**Amendments to the Specification:**

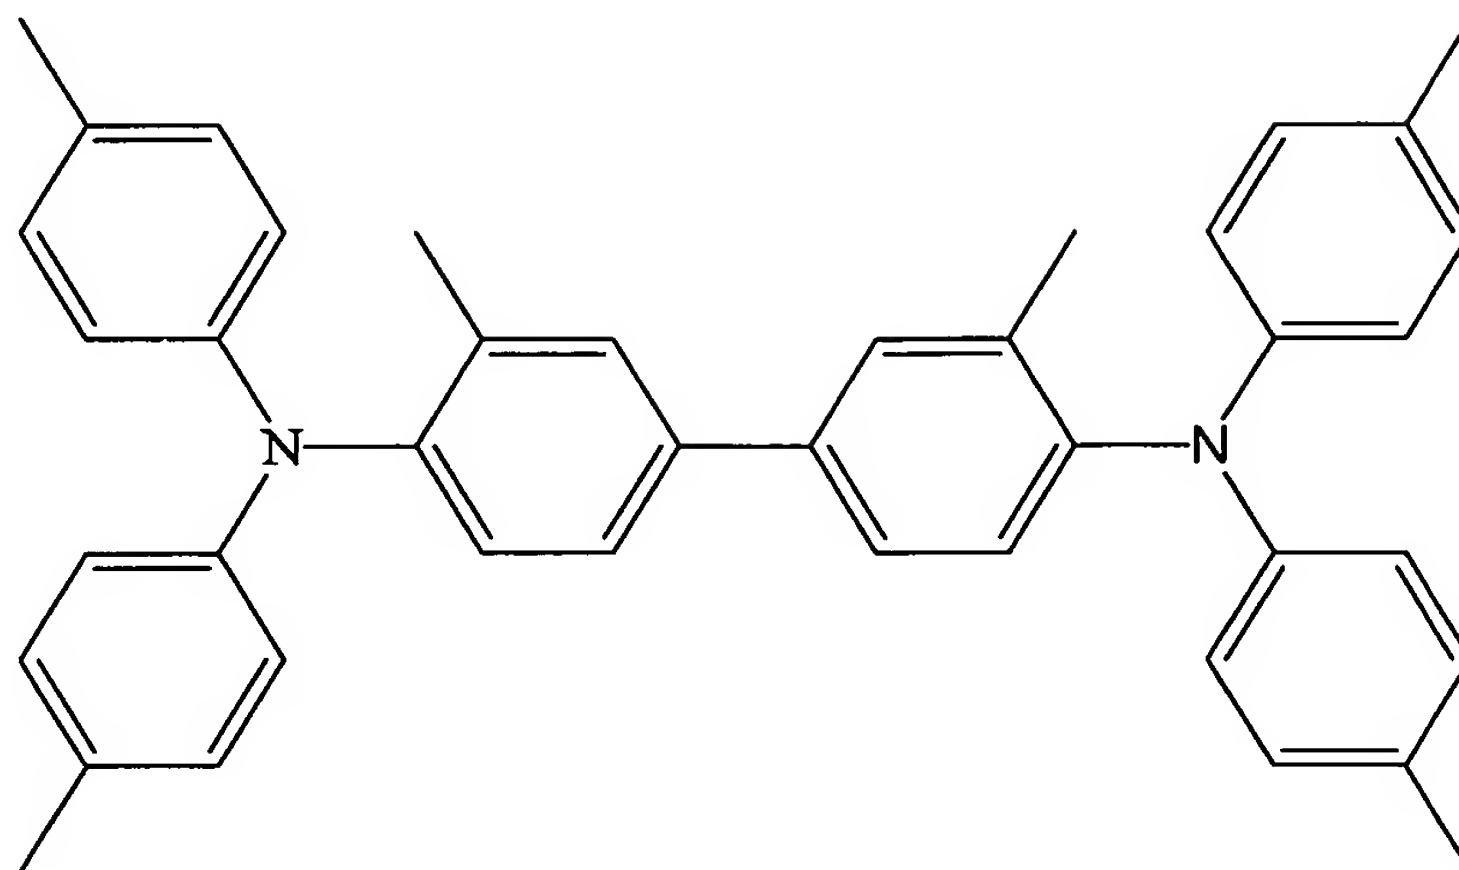
Please replace the paragraph beginning on page 6, line 3 with the following amended paragraph:

In one embodiment of the present invention, as shown in Figure 4, the OLED structure includes a substrate 40, an anode 41 over the substrate 40, a first HTL 42 over the anode 41, a second HTL 43 that is doped with a phosphorescent material over the first HTL 42, a first ETL 44 that is doped with a phosphorescent material over the second HTL 43, a second ETL 45 over the first ETL 44, and a cathode 46 over the second ETL 45.
